RULES FOR THE SURVEY AND CONSTRUCTION OF STEEL SHIPS

Common Structural Rules for Bulk Carriers and Oil Tankers

Rules for the Survey and Construction of Steel Ships
Part CSR-B&T **2022** **AMENDMENT NO.1**

Rule No.5 10 March 2022

Fig. 3 Net Sectional Properties of Local Supporting Members (Continued)

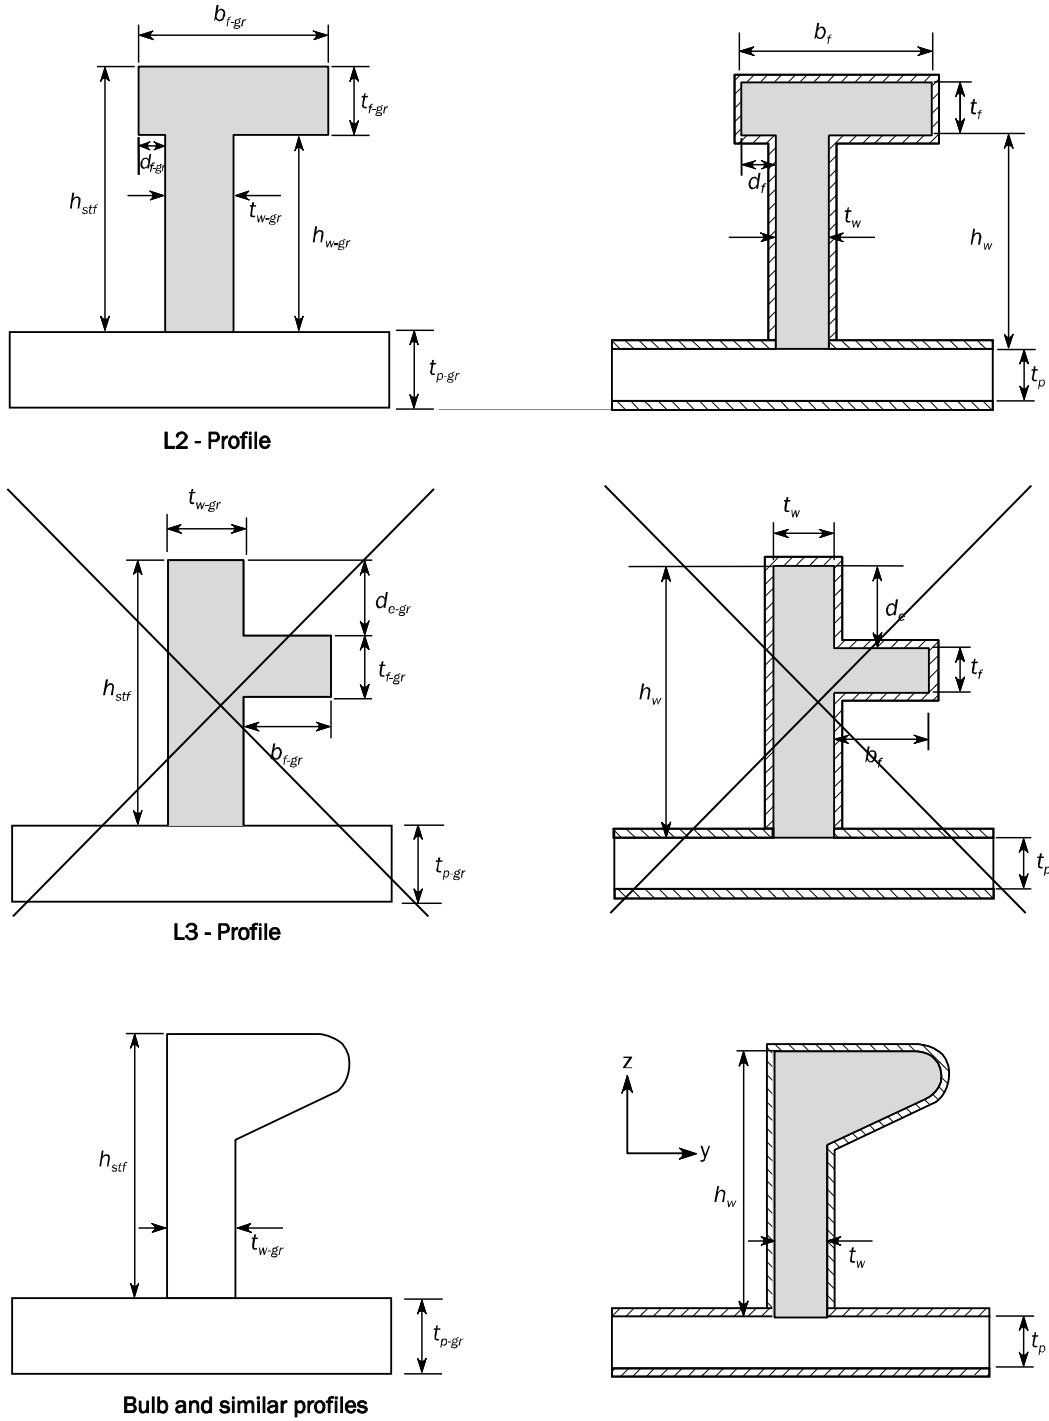
~~d_w : Distance in mm , from the upper edge of the web to the top of the flange for $L3$ profiles, see **Fig. 3**.~~

d_f : Distance in mm , for the extension of flange for $L2$ profiles, see **Fig. 3**.

Fig. 3 has been amended as follows.

Fig. 23 Reference Point for Calculation of Section Modulus and Hull Girder Stress for Local Scantling Assessment

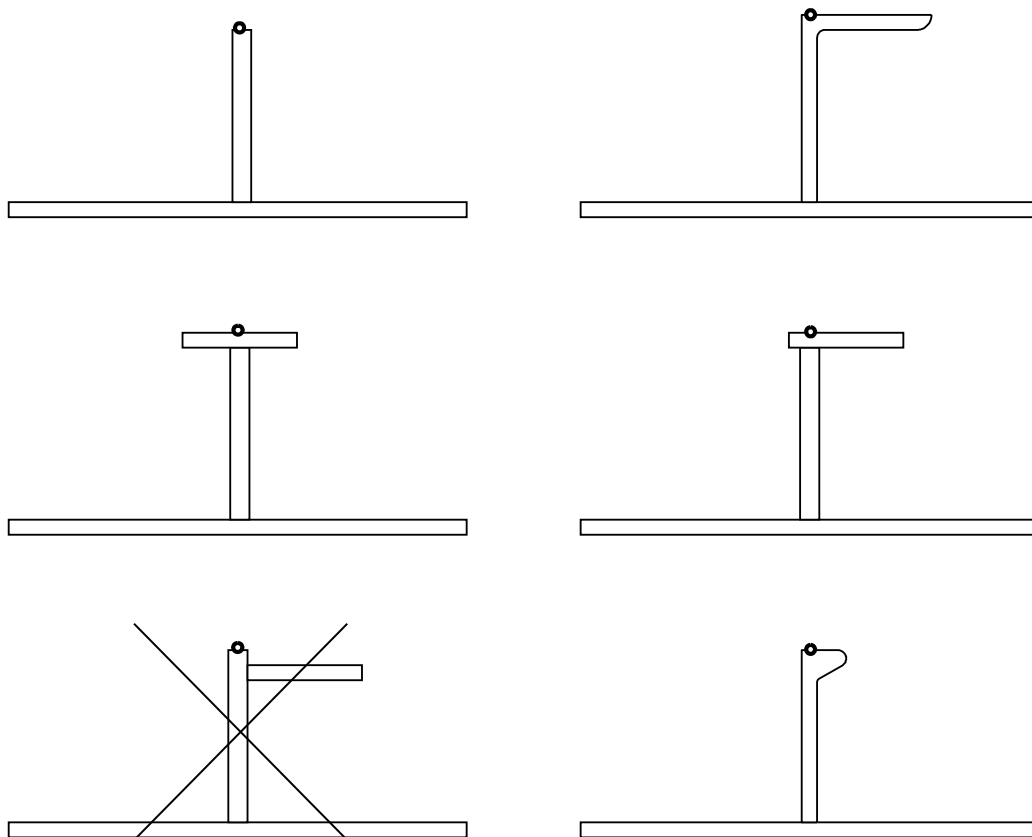
Fig. 23 has been amended as follows.

Fig. 1 has been amended as follows.

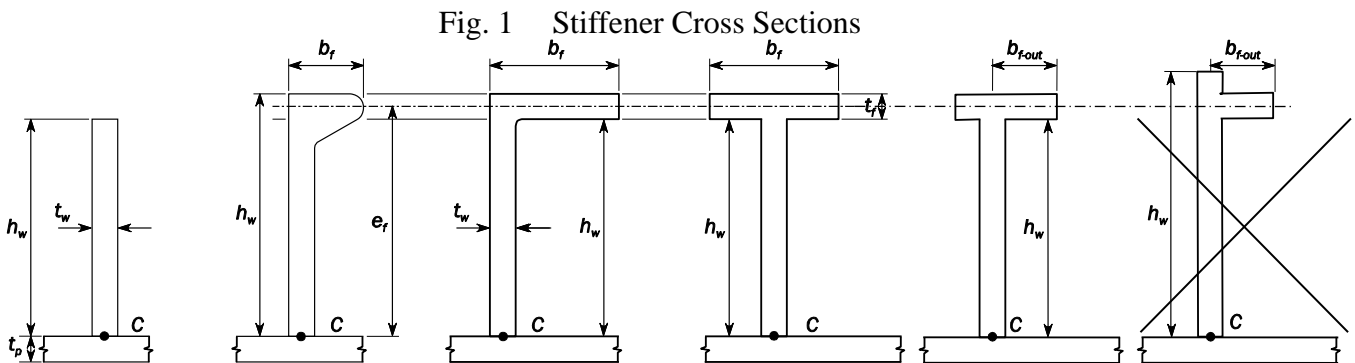
e_f : Distance from attached plating to centre of flange, in mm , as shown in **Fig.1** to be taken as:

$$\underline{e_f = h_w - d_w - 0.5t_f \text{ for L3 profile.}}$$

Fig. 1 Example of Hatch Cover Fitted with U Type Stiffener

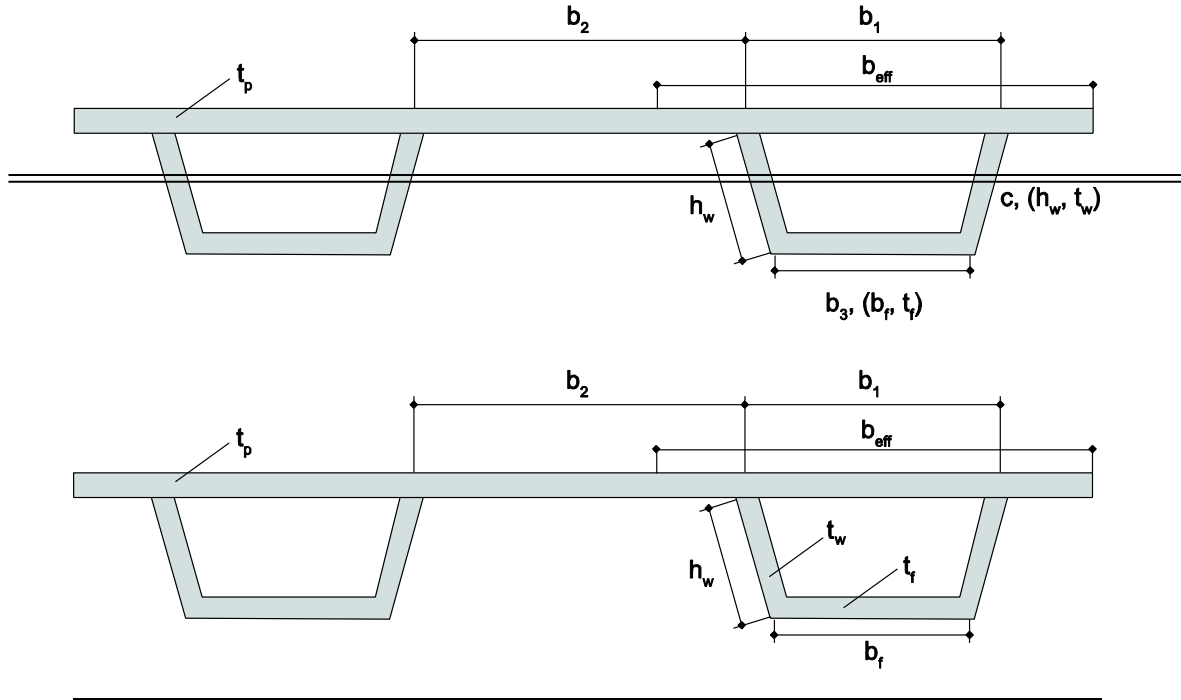
~~The hatch covers fitted with U type stiffeners as shown in Fig. 1 are to be checked by means of FE analysis. In transverse section of the stiffener, nodes are to be located at the connection between the web of the U type stiffener and the hatch cover plate as well as at the connection between the web and the flange of the U type stiffener. The buckling assessment as described in 5.2.3, 5.3.4 and 5.4.6 can be made considering only the stresses given by the FE analysis.~~

Hatch covers fitted with U-type stiffeners as shown in Fig. 1 are to be assessed by means of FE analysis. The geometry of the U-type stiffeners is to be accurately modelled using shell/plate elements. Nodal points are to be properly placed on the intersections between the webs of a U-type stiffener and the hatch cover plate, and between the webs and flange of the U-type stiffener.

Fig. 3 Hatch cover top/bottom plating structures

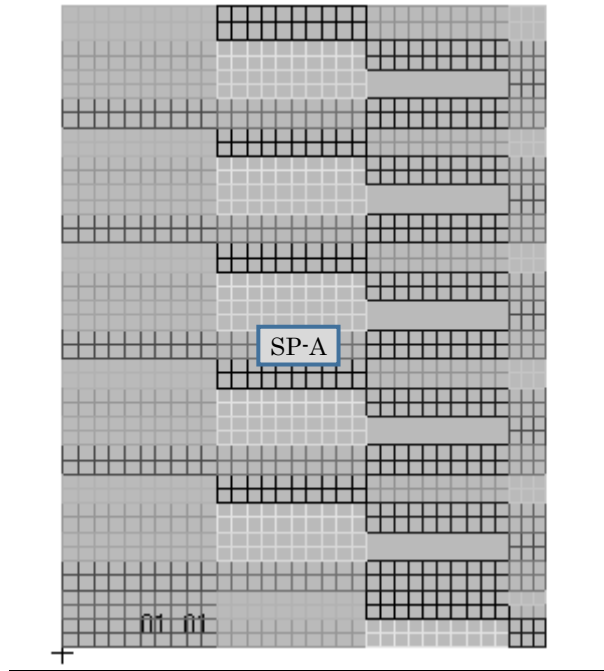
unstiffened panel (UP). Assessment Method A (-A) and Method B (-B) as defined in **Pt 1, Ch 8, Sec 1, 3** are to be used in accordance with **Table 4, Fig. 3** and **Fig. 4**. For a web panel with opening, the procedure for opening should be used for its buckling assessment.
